Draft changes to clause 95 including TxVEC – rev2

MMF ad hoc working document
Jonathan King

Figure 95–3—TxVEC conformance test block diagram

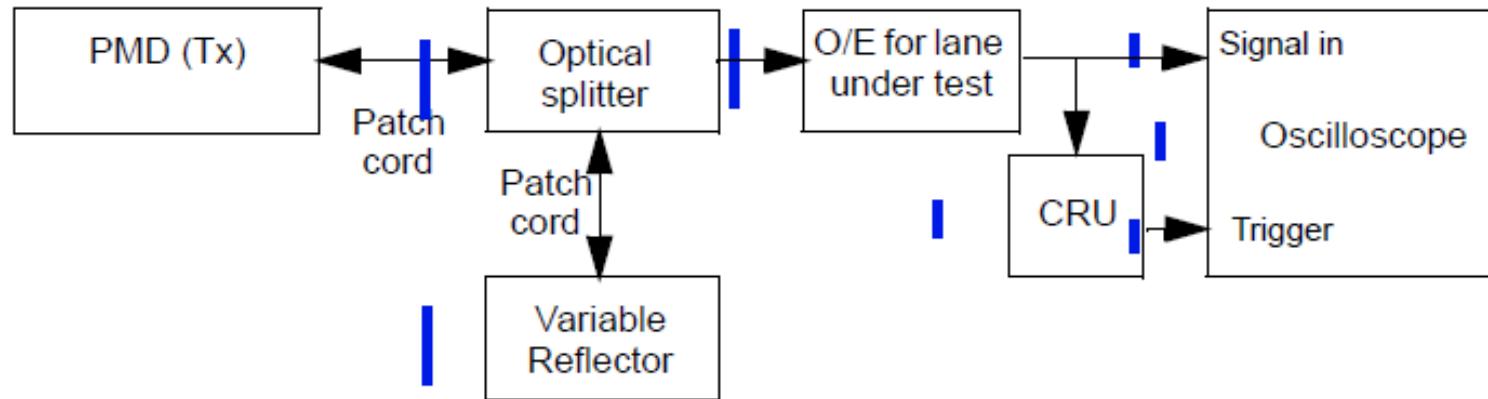
New section 95.8.5.1 test set up

A block diagram for the TxVEC conformance test is shown in Figure 95–3. Other measurement

Each optical lane is tested individually with all other lanes in operation. The optical splitter and variable reflector are adjusted so that each transmitter is tested with an optical return loss of 12 dB.

The combination of the O/E and the oscilloscope used to measure the optical waveform has a fourth-order Bessel-Thomson filter response with a bandwidth of 12.6 GHz. Compensation may be made for any deviation from an ideal fourth-order Bessel-Thomson response.

The clock recovery unit (CRU) has a corner frequency of 10 MHz and a slope of 20 dB/decade.

Figure 95–4—Illustration of the TxVEC measurement

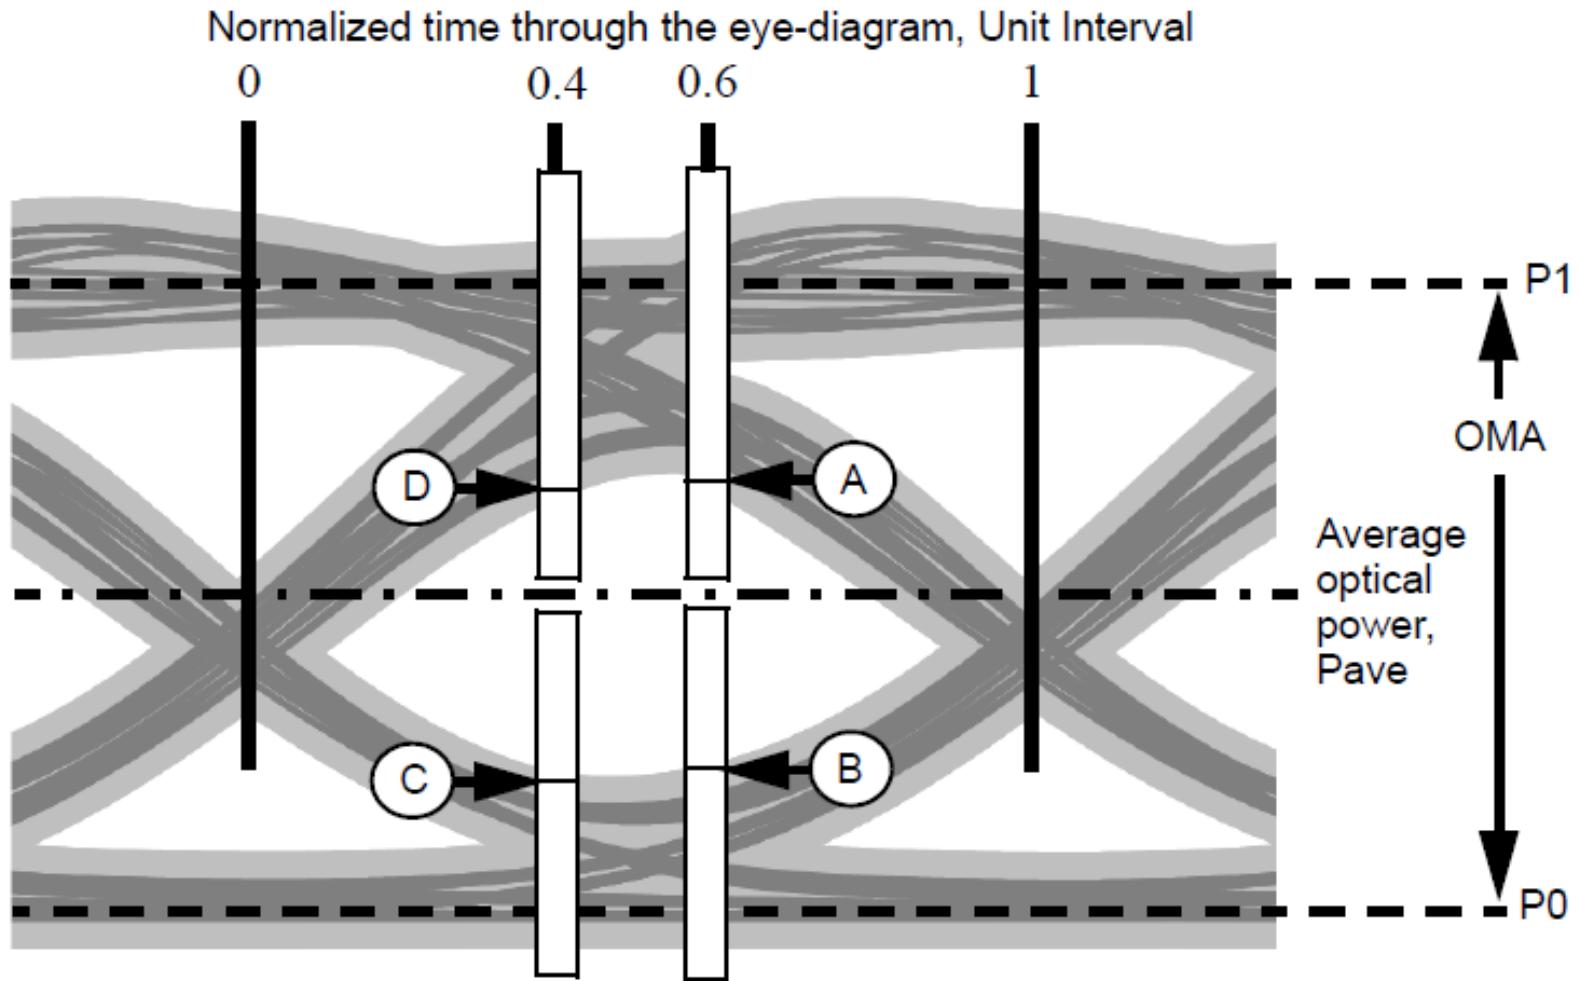
The oscilloscope is set up to accumulate samples for the optical eye-diagram of the transmitter under test, as illustrated in Figure 95–4.

The 0 UI and 1 UI crossing points are determined by the time average of the eye crossing points, as measured at the average optical power level, as illustrated in Figure 95–4.

Four vertical histograms are measured through the eye, centered at 0.4 UI and 0.6 UI, and above and below the average optical power of the eye-diagram, as illustrated in Figure 95–4.

Each histogram has a width of 0.04 UI. Each histogram window has one height boundary set close to average power level of the eye-diagram, and the other height boundary is set beyond the outer-most samples of the eye, so that no further eye samples would be captured by increasing the outer boundary of the histogram. Starting from the boundary of the histogram closest to the average optical power level, the optical power at which the cumulative distribution of each histogram equals the 0.005th percentile of the total number of samples for each histogram is recorded (these are the powers A, B, C, and D illustrated in Figure 95–4).

$TxVEC$ is defined as the largest of the four quantities given by Equation (95–1) to Equation (95–4):
